This errata sheet provides updated information on Stratix® devices. This document addresses known issues and includes methods to work around the issues.

Stratix Family Issues

Figure 2. Gated Lock in Internal Logic Circuit

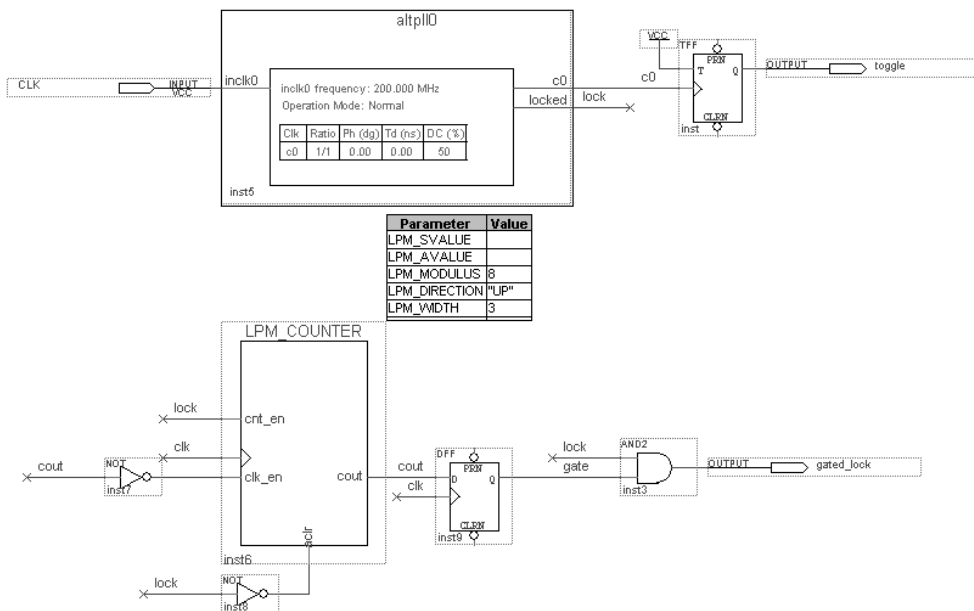
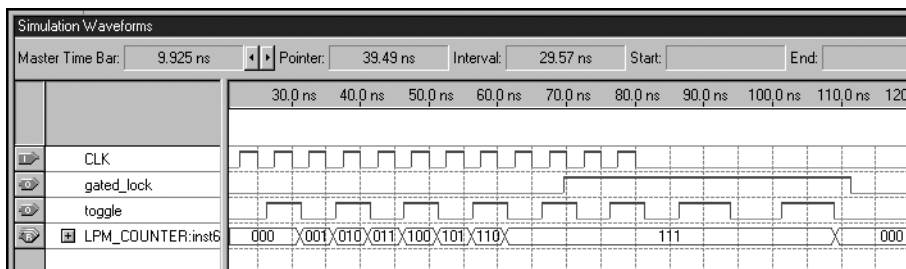
There is a run-through problem in the GLOCK counter that causes the counter to operate incorrectly. Support for the gated_lock circuitry was disabled in the Quartus II software version 2.1. Therefore, the gated_lock feature is unavailable in Stratix devices.

The work around for this problem is to gate the lock signal in internal logic. Altera recommends using a two-input AND gate to gate the lock signal with a counter. The number of bits in the counter (LPM_WIDTH) can be adjusted to control how many clock cycles before the gated_lock signal is released. The counter width in the reference design is currently 3. See [Figure 2](#).
